GREATER NEW HAVEN WATER POLLUTION CONTROL AUTHORITY

IMPROVING FATS OIL AND GREASE RECEIVINGS

Project SSF 2020-03

ADDENDUM #3

A-00-501

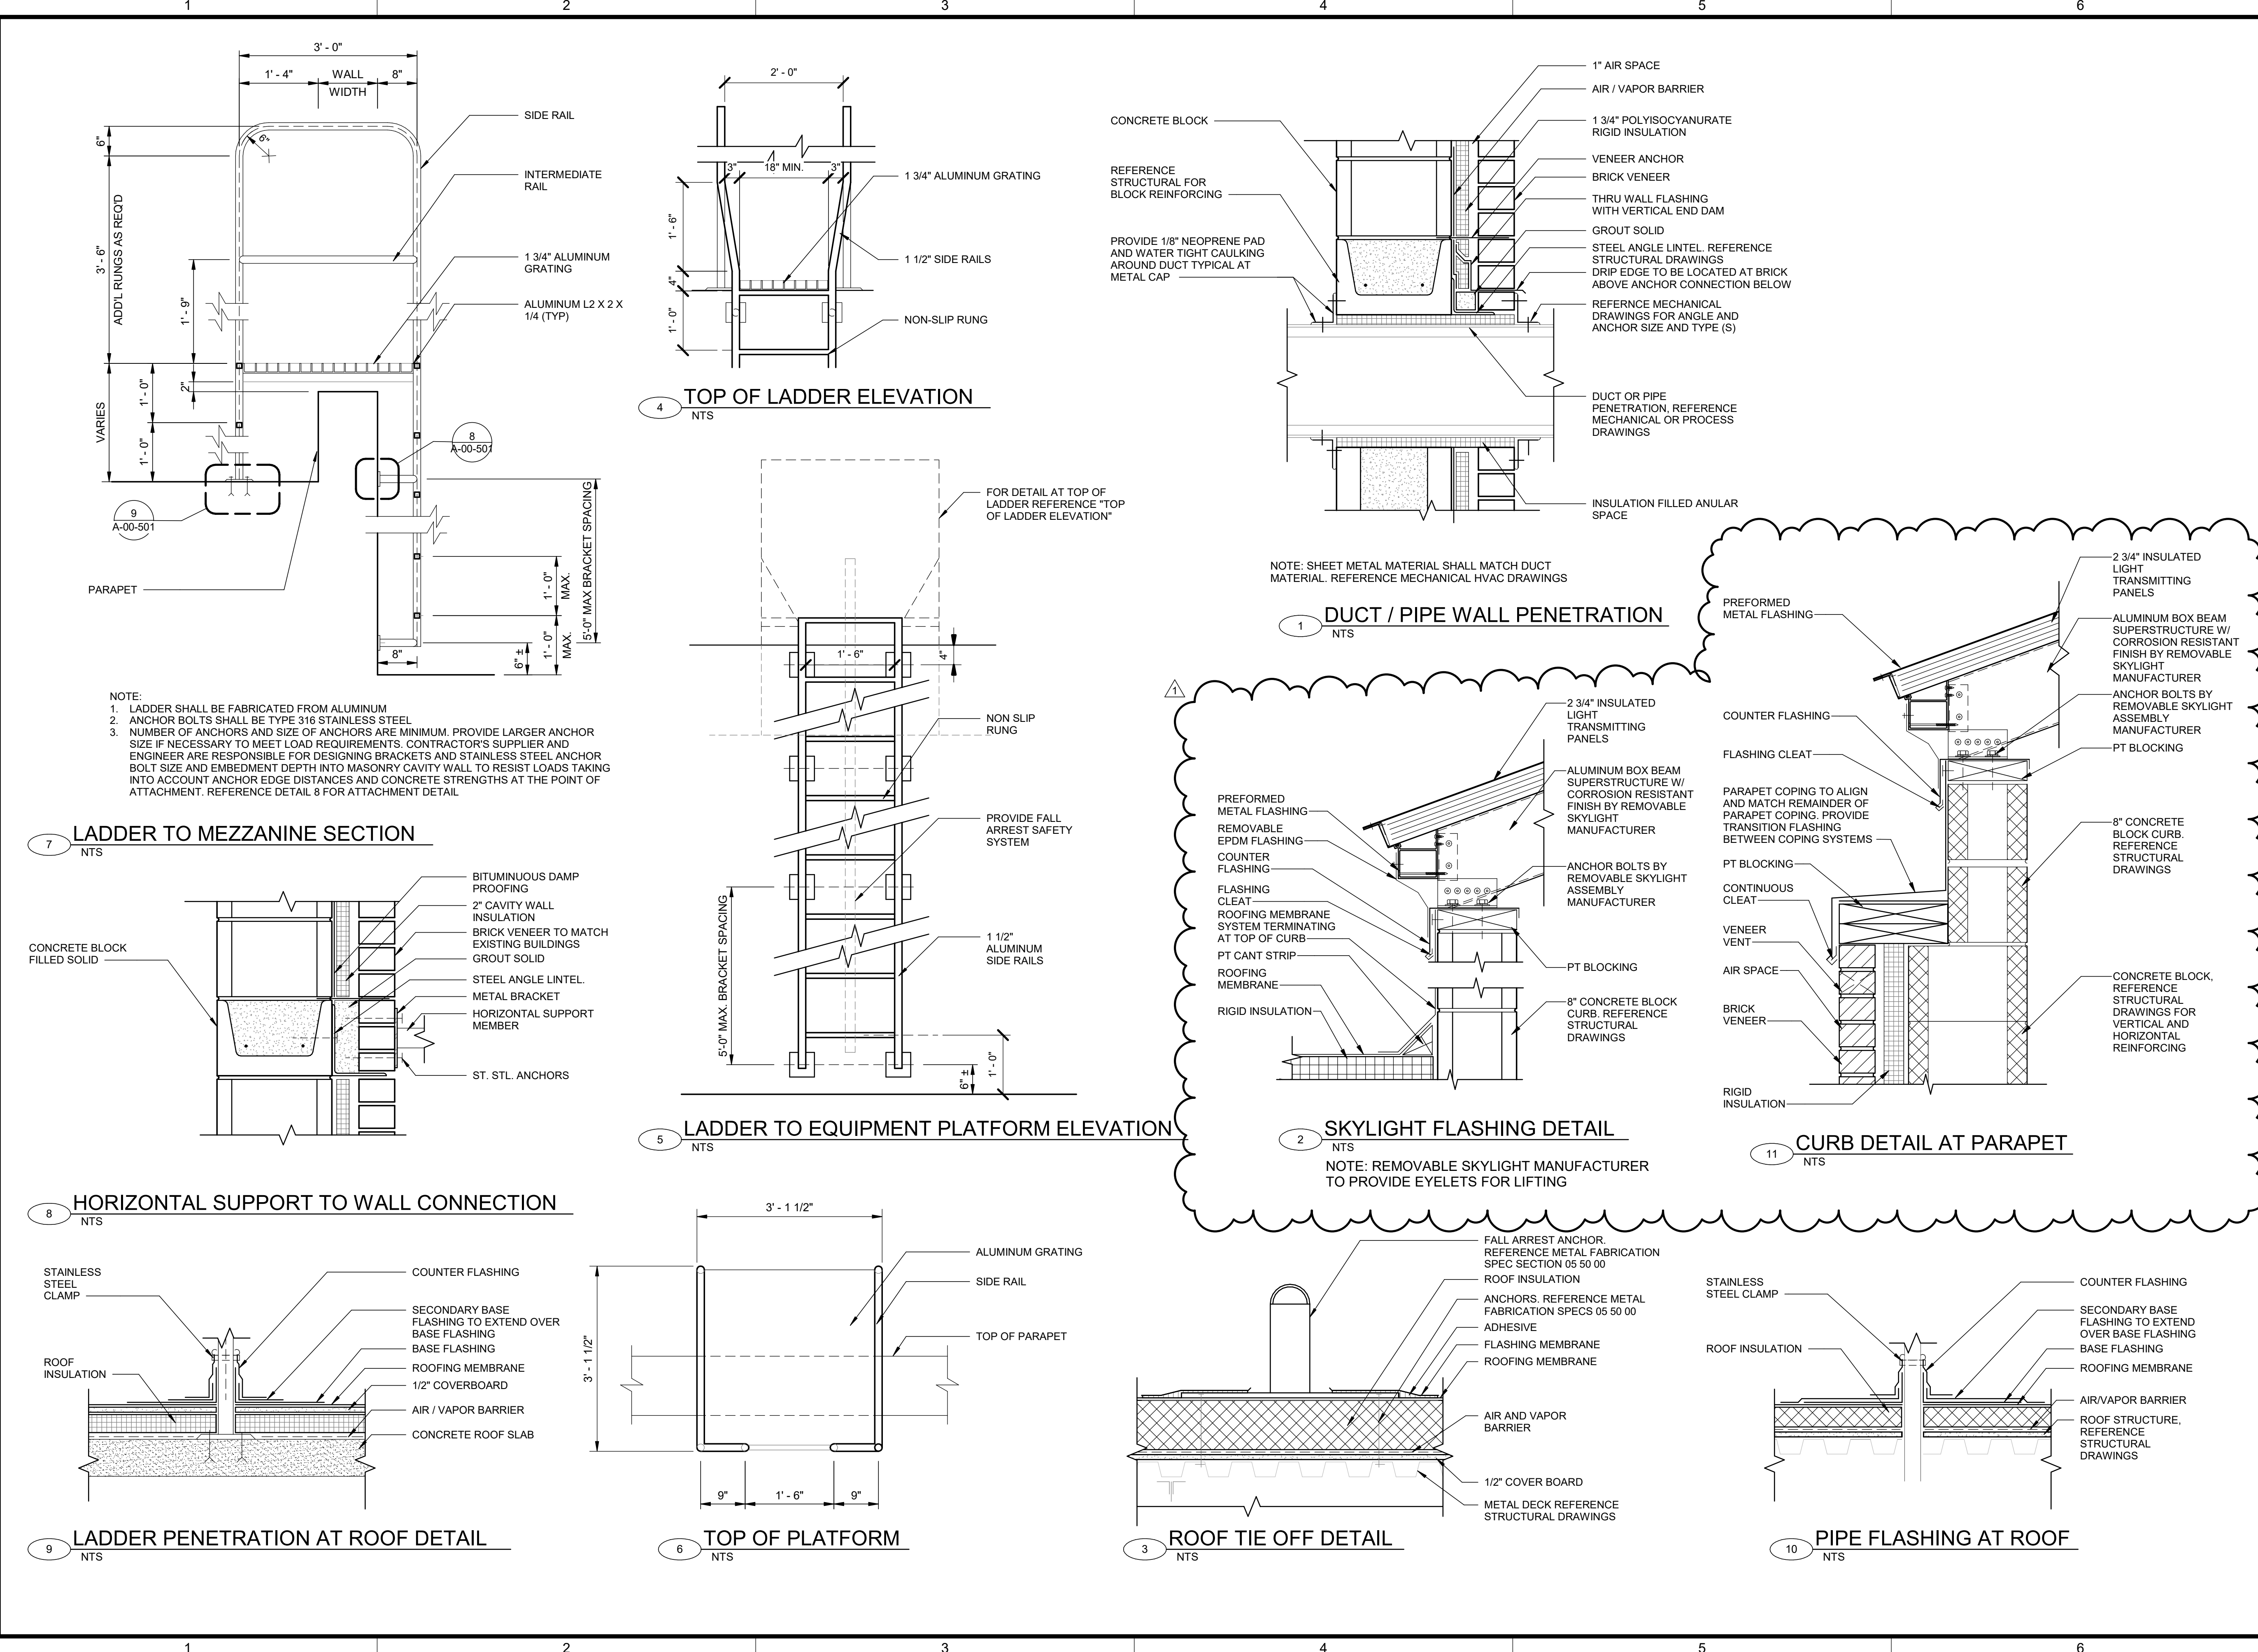
- i. **Response:** Use Specification Section 07 10 00.
5. **Question:** Drawing A-00-501 – Detail 2, skylight flashing detail, calls for a concrete curb with water stop (reference structural drawings). Drawing S-63-107, Roof Plan does not show a curb around the skylight openings. Please clarify if a concrete curb is required, if so, please provide a detail. If a concrete curb is not required, provide a detail for the curb.

- i. **Response:** A concrete curb is required. Refer to Attached detail.

DRAWING NUMBER
S-63-107

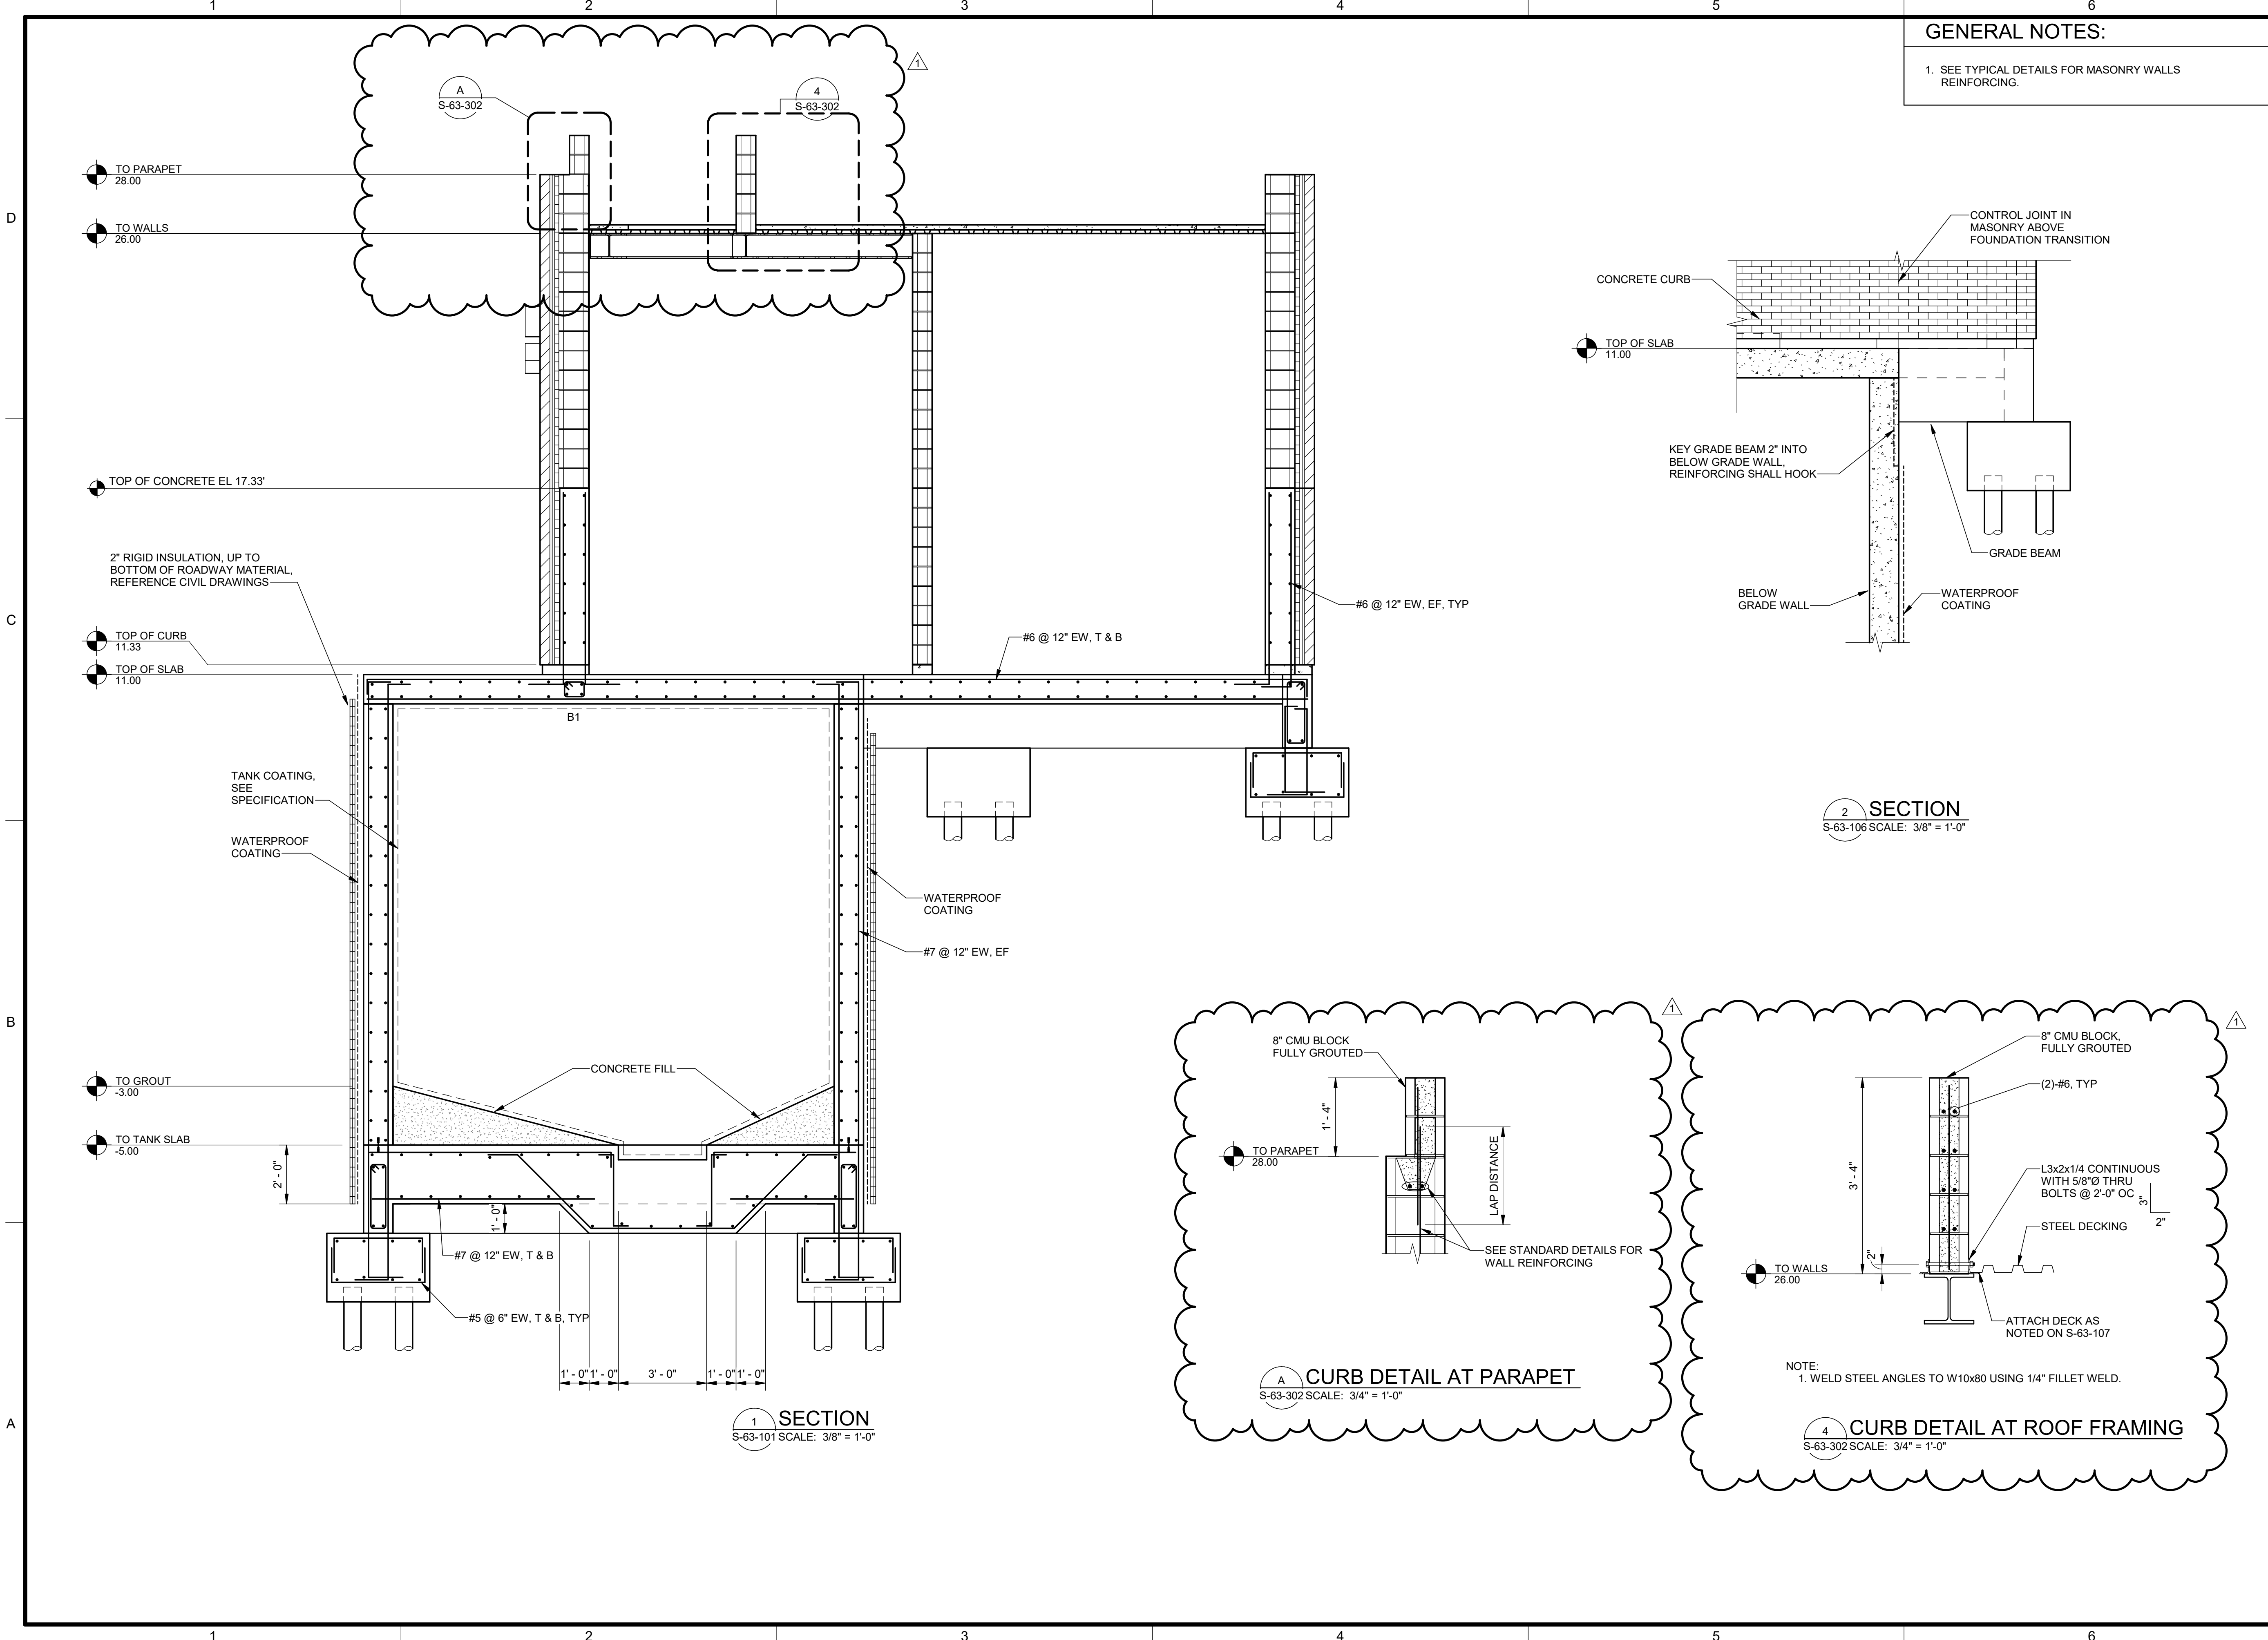
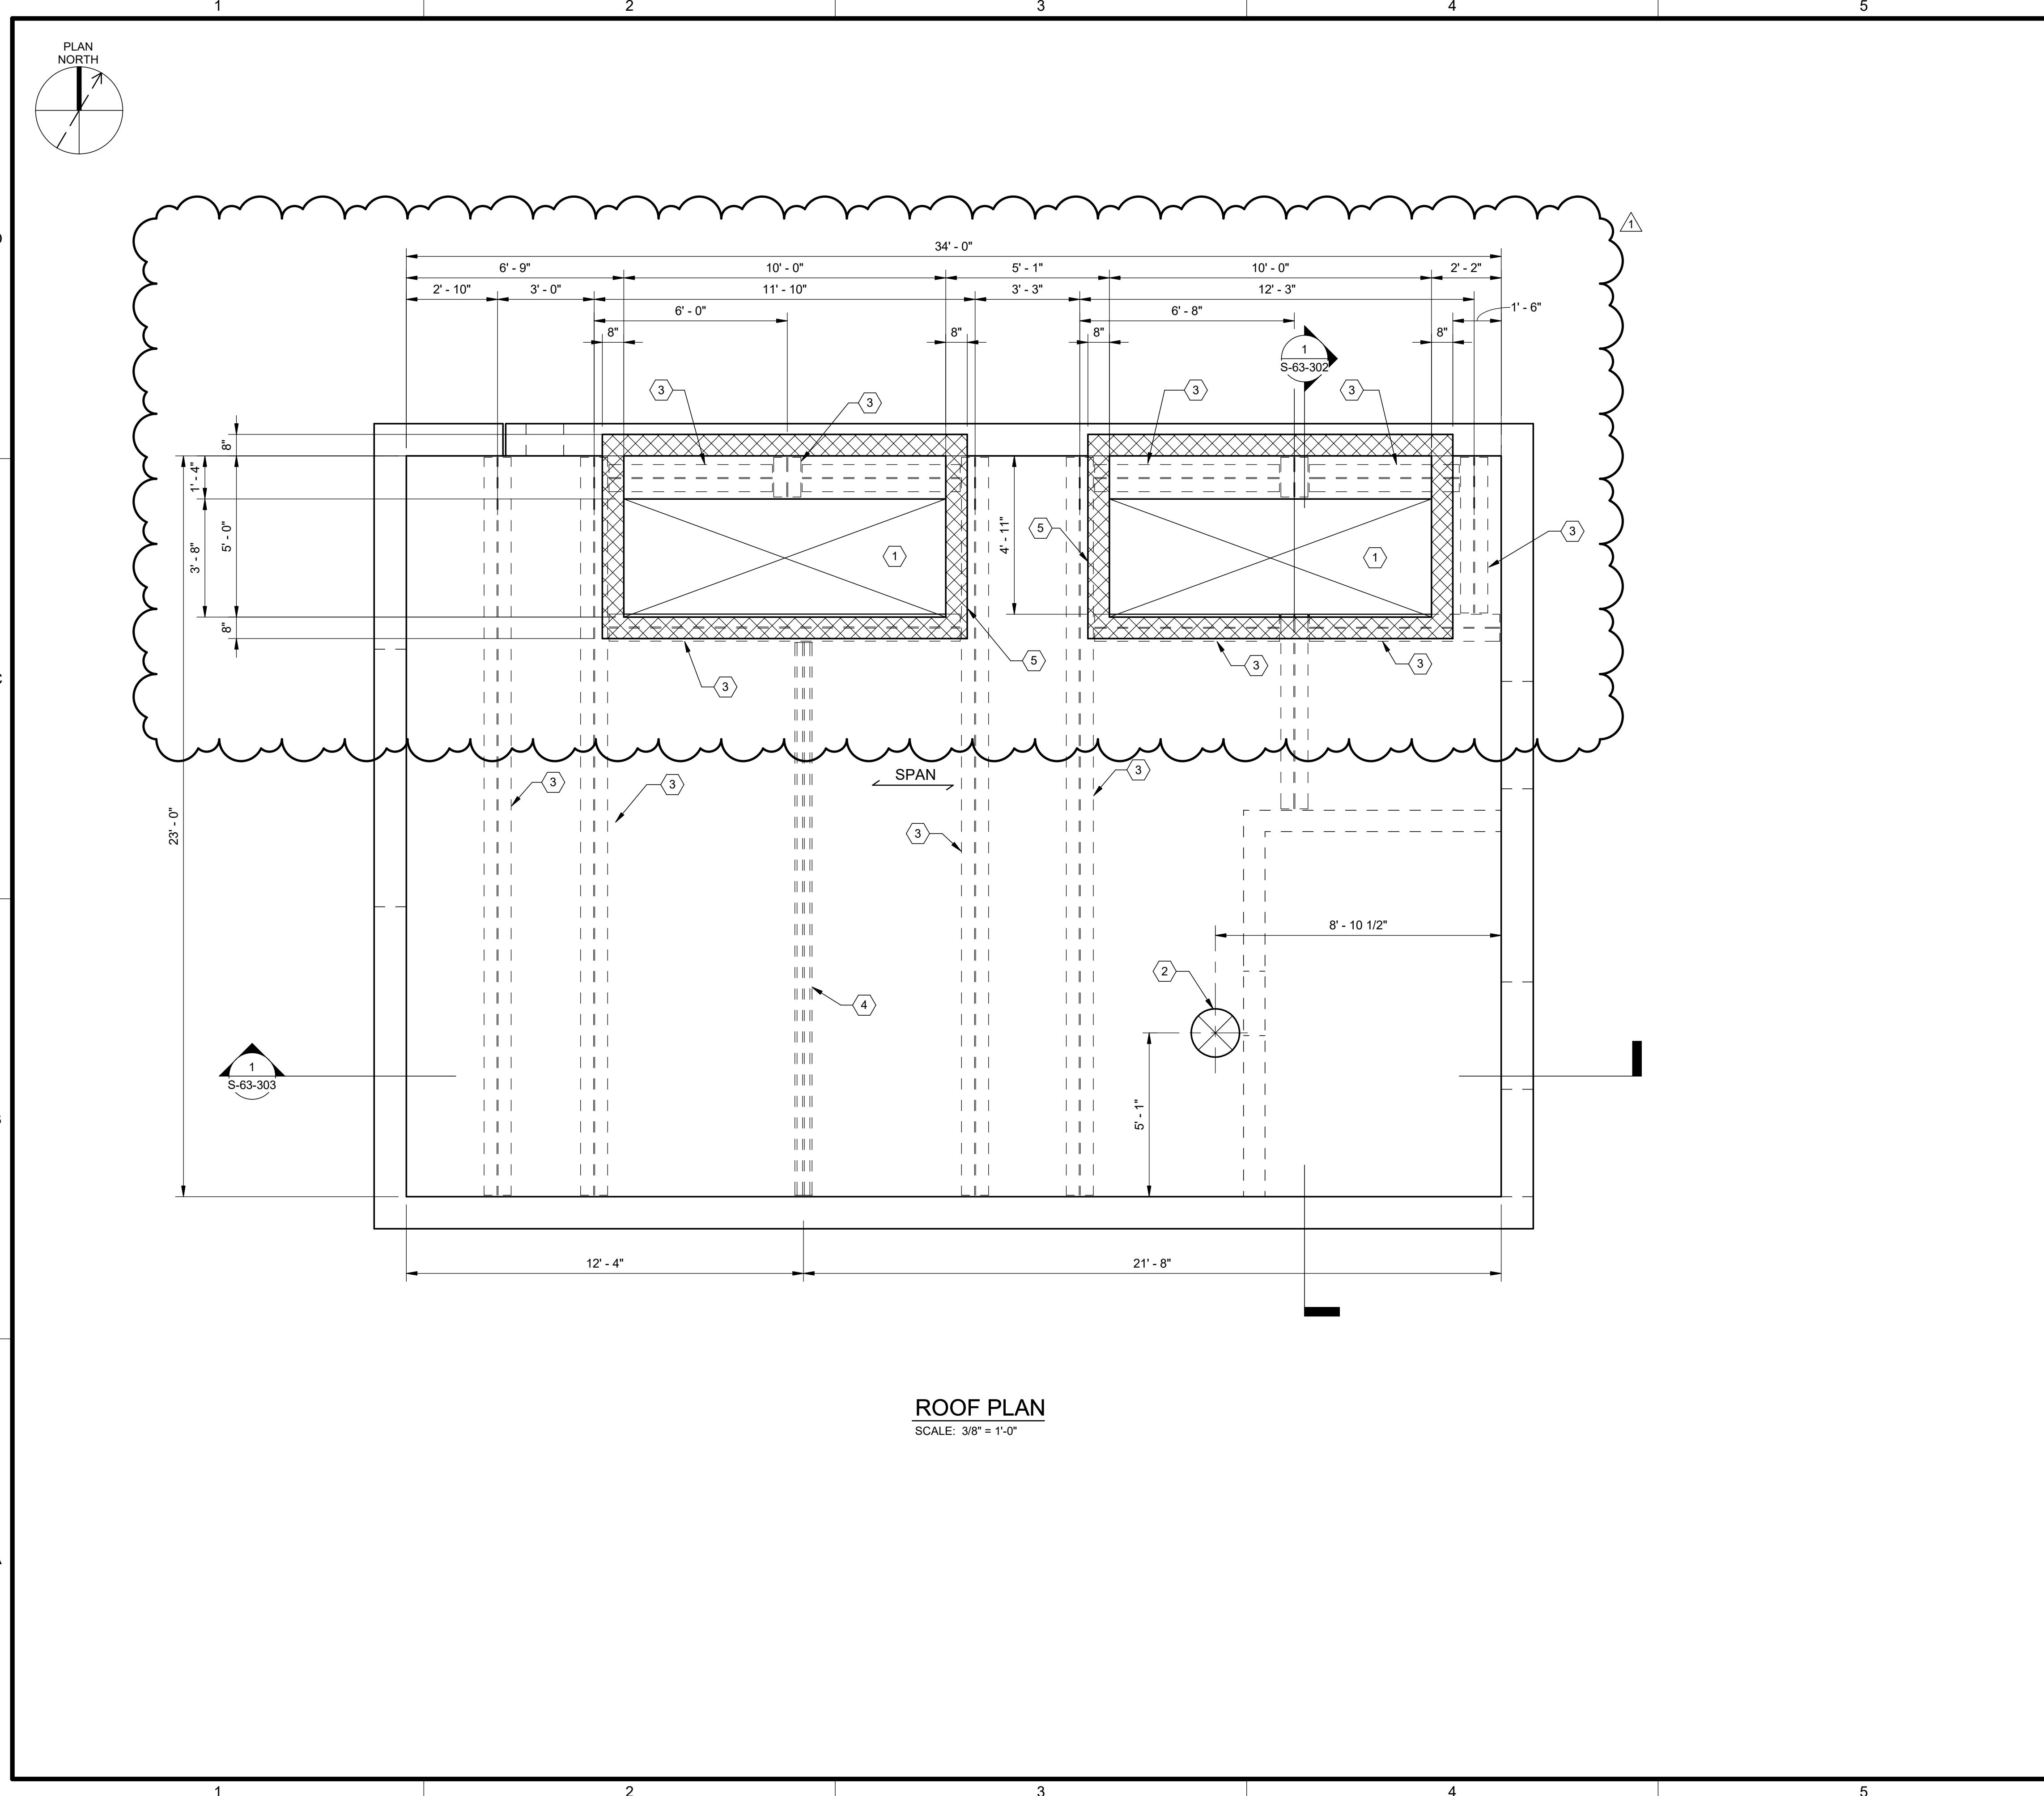
12. **Question:** Drawing S-63-107 – Can you take a second look at the skylight support framing plan? It appears that a support is missing on the eastern skylight and not clear on the framing intent is on the western skylight.

- i. **Response:** Refer to attached detail for update to skylight support.
13. **Question:** There are comments in the Haley & Aldridge Geotech report that there may be contaminated soils in the area of the existing 25,000 fuel storage tank that would have to be removed. The excavation to remove this take will need to occur in a shored hole, which will limit horizontal and deeper over-excavation if required. Confirm that if additional shoring is required to over-excavate for contaminated soil removal, this will be treated as a change of conditions to the scope of work.
